2	11/26/25	ADD SCD RM-3.1

BRIDGE NO. CUY-77-15.46
IR 77 OVER WOODLAND AVE.

ESTIMATED QUANTITIES
BRIDGE NO. CUY-77-15.46
IR 77 OVER WOODLAND AVE.

GENERAL PLAN
BRIDGE NO. CUY-77-15.62
IR 77 OVER E. 22ND ST.

WOODLAND AVE.
REAR LEFT

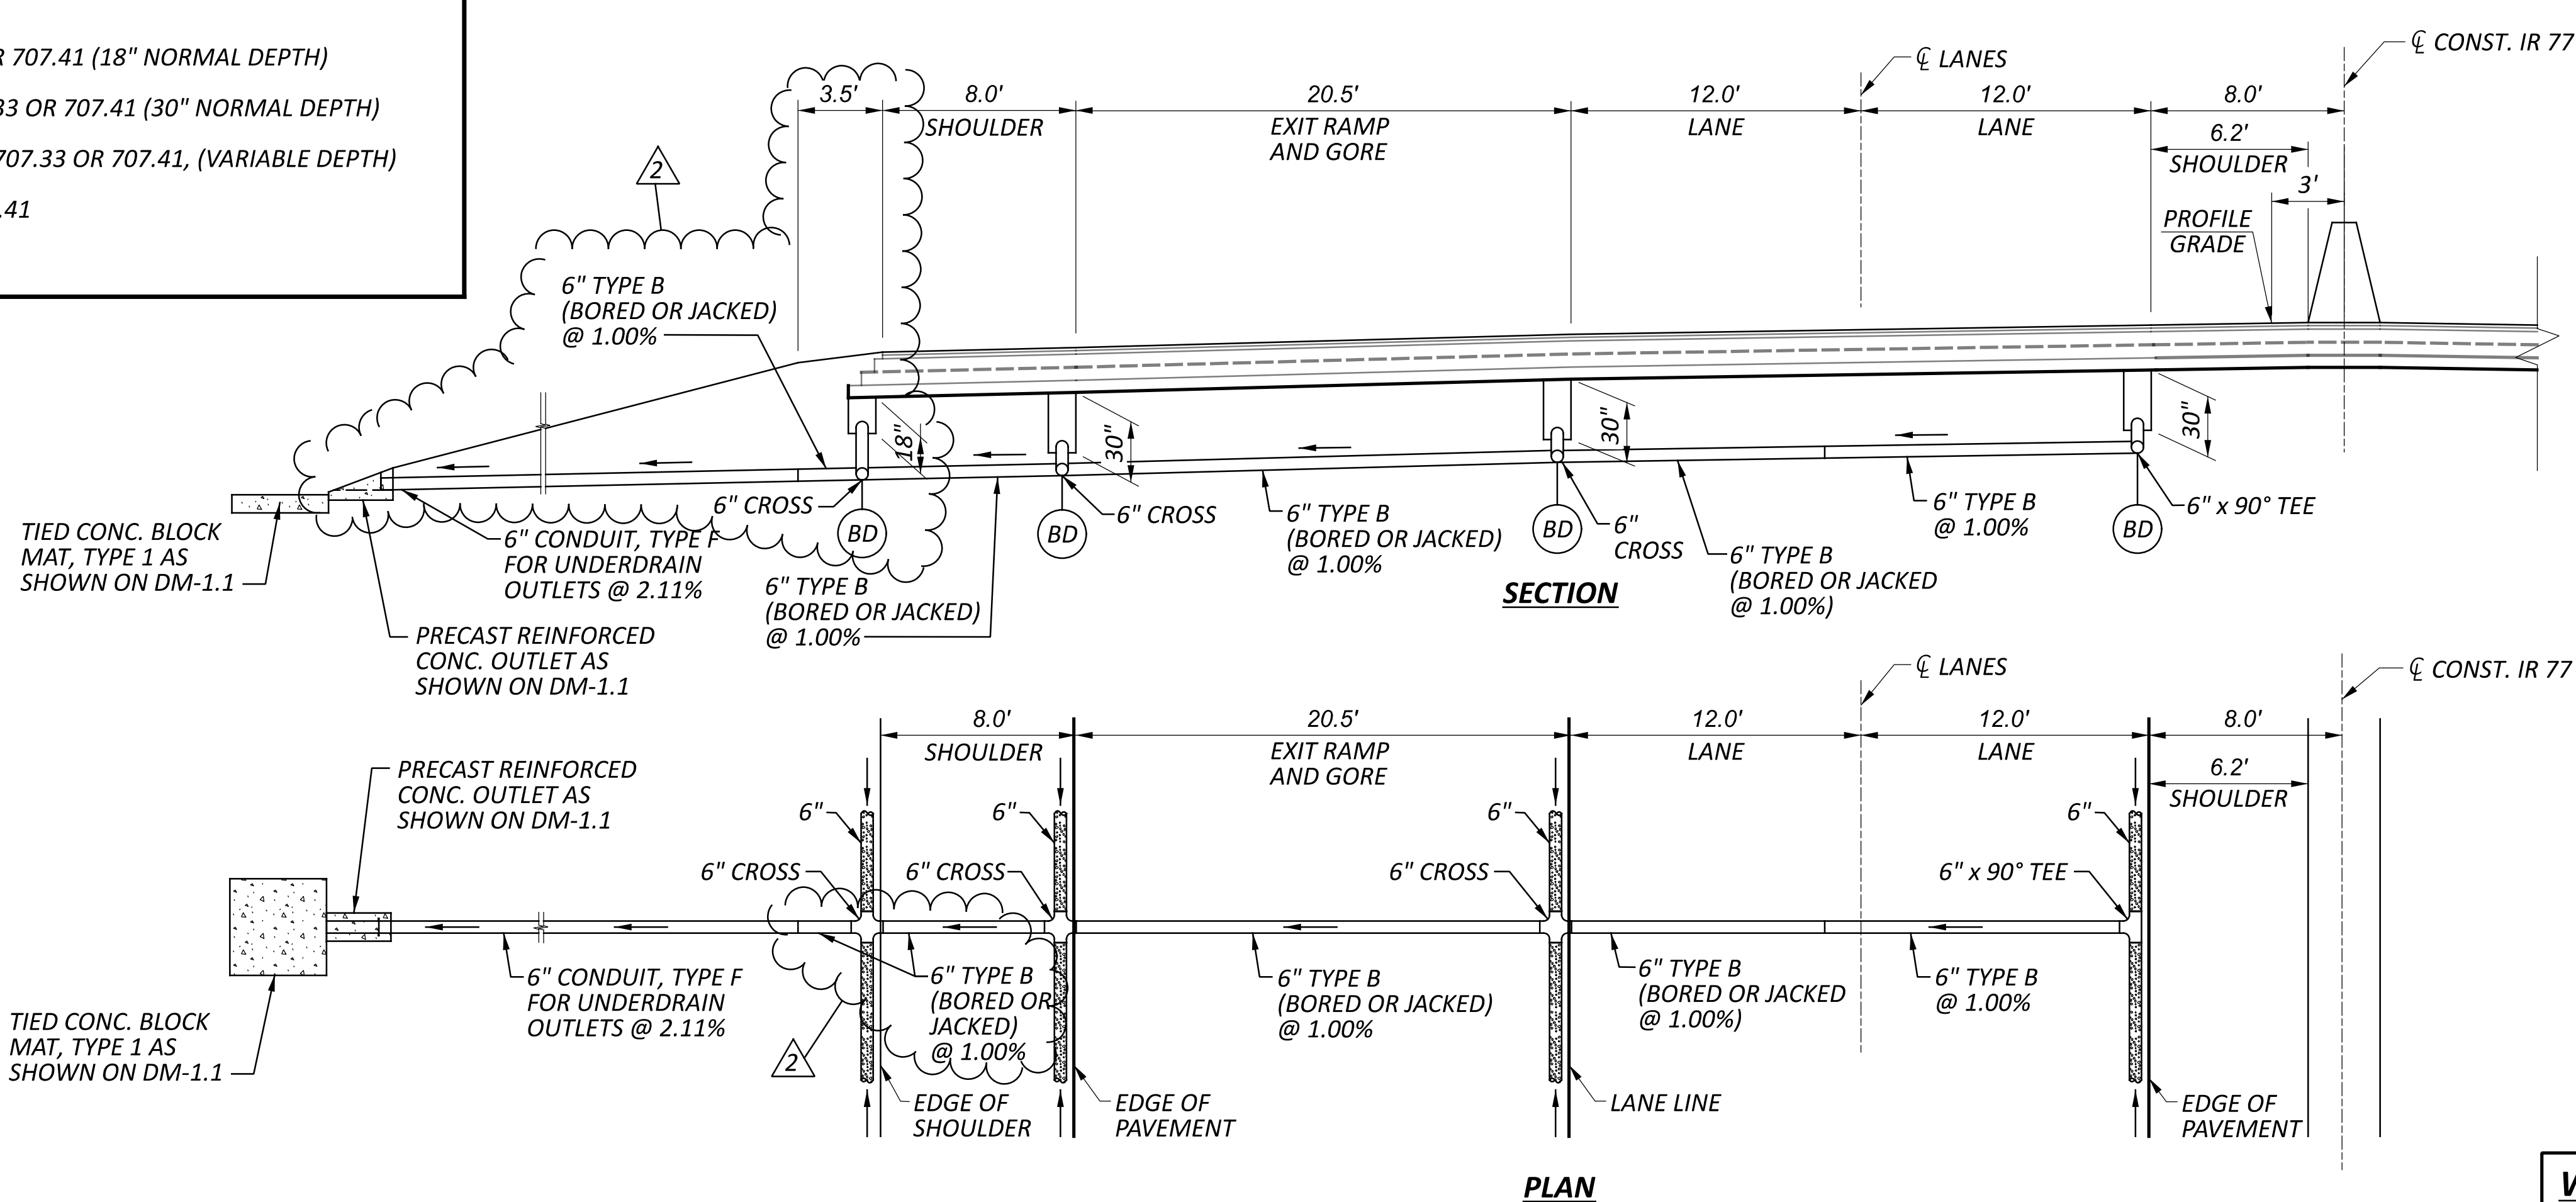
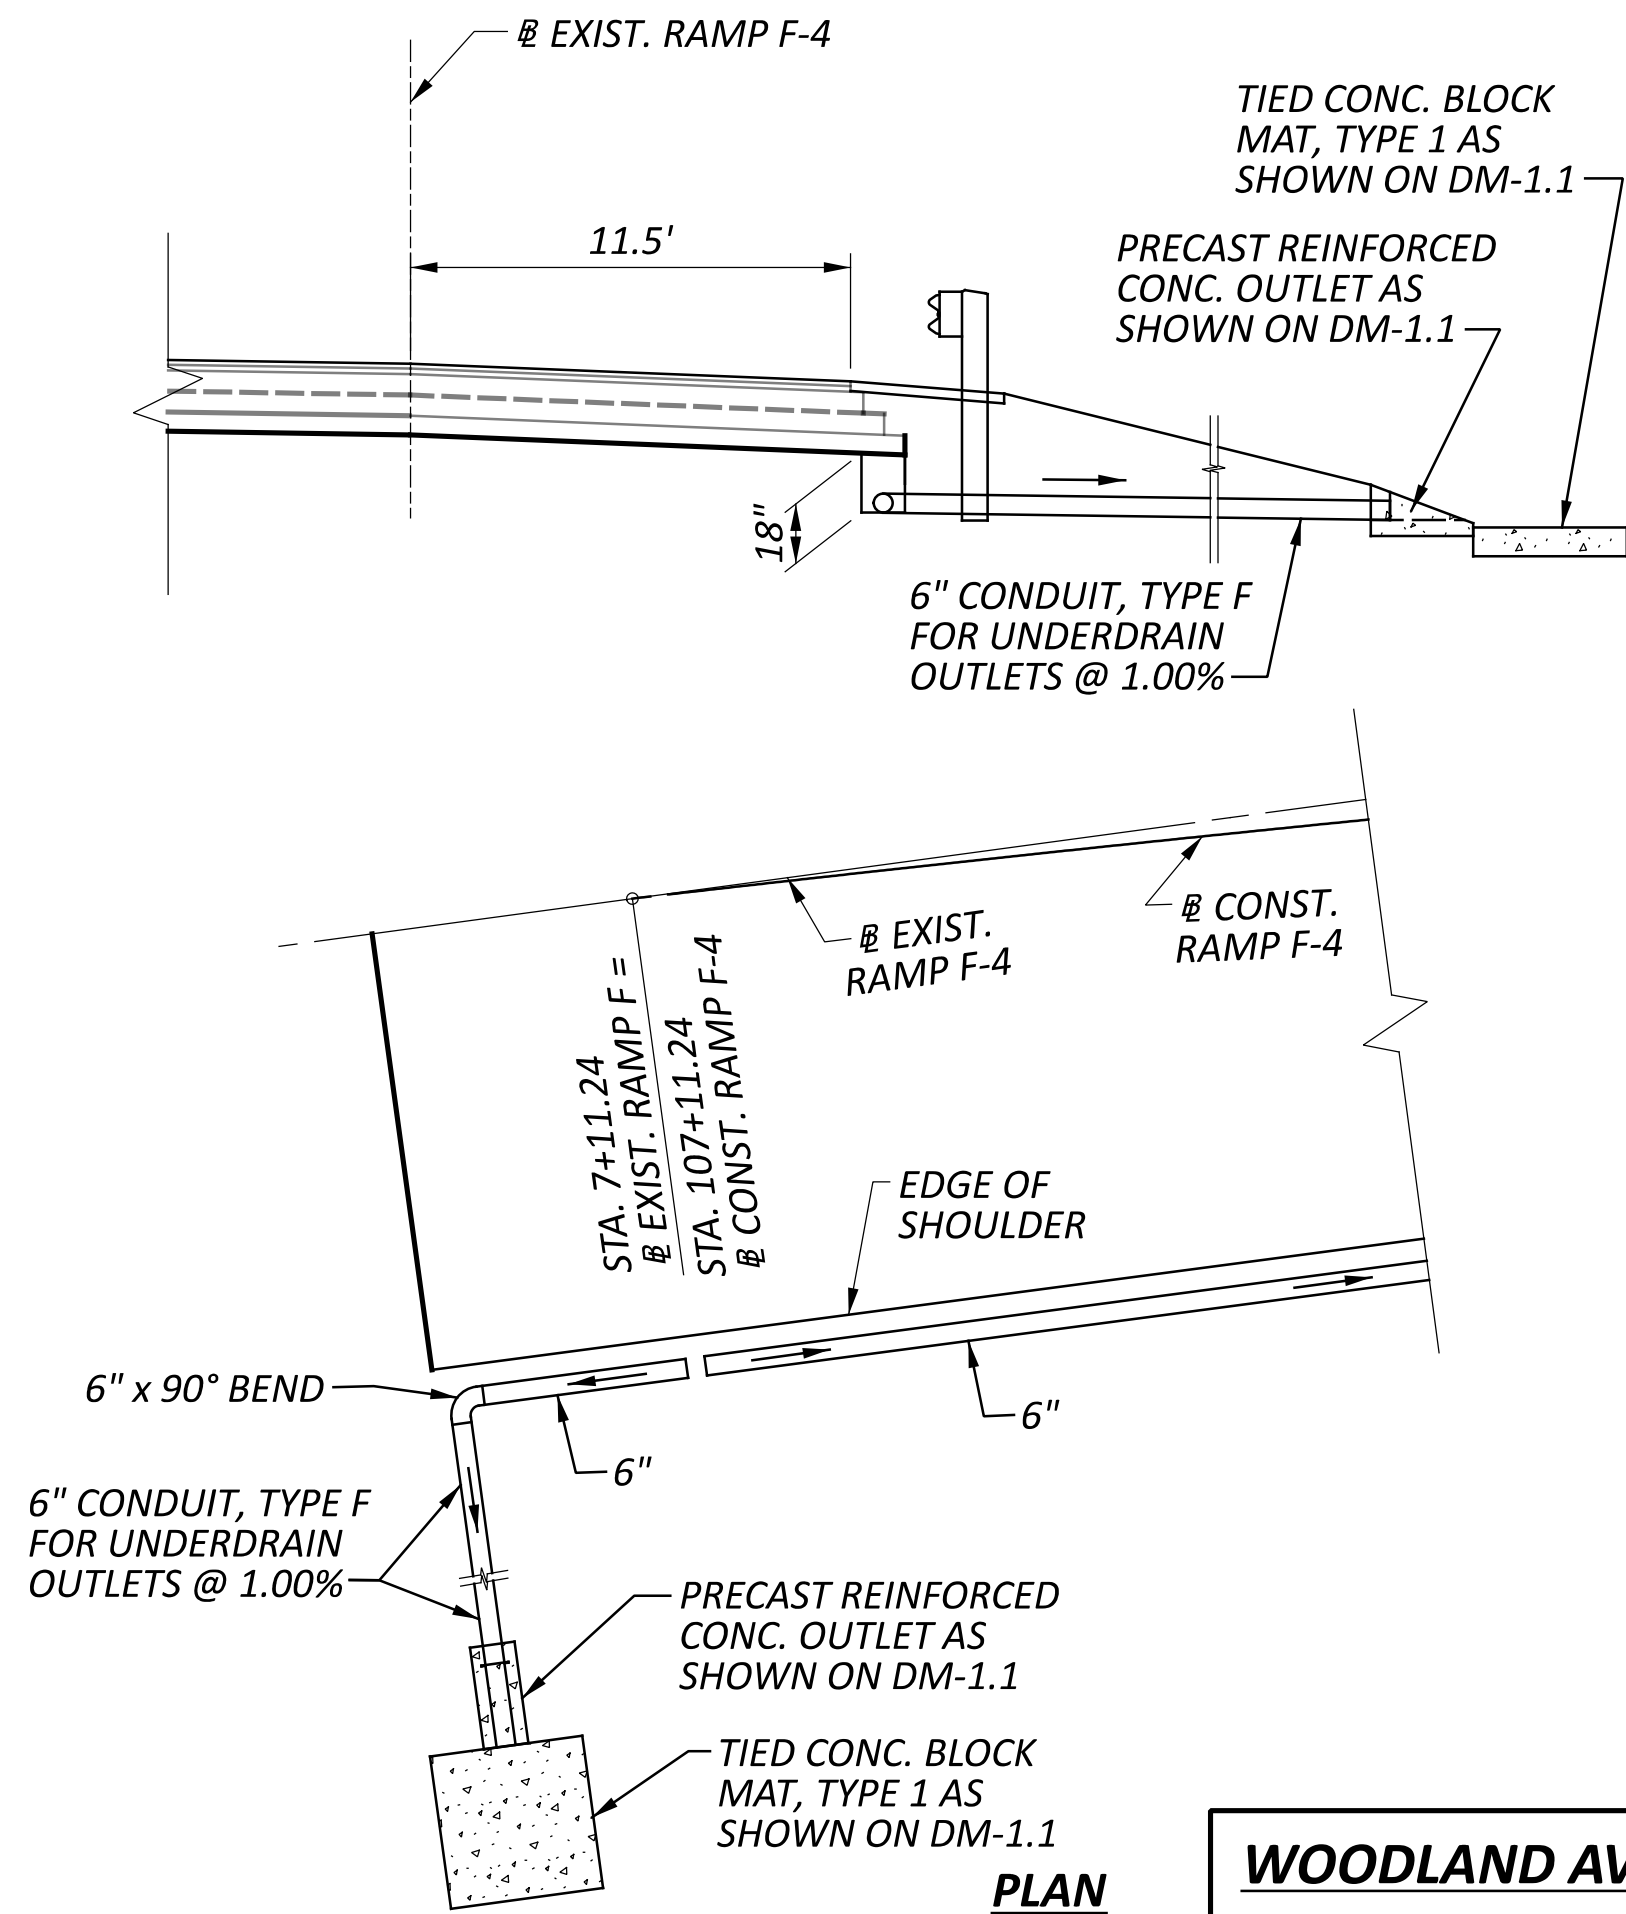
2	11/26/25	REVISE UD OUTLET SLOPE, 6" TYPE B LENGTH
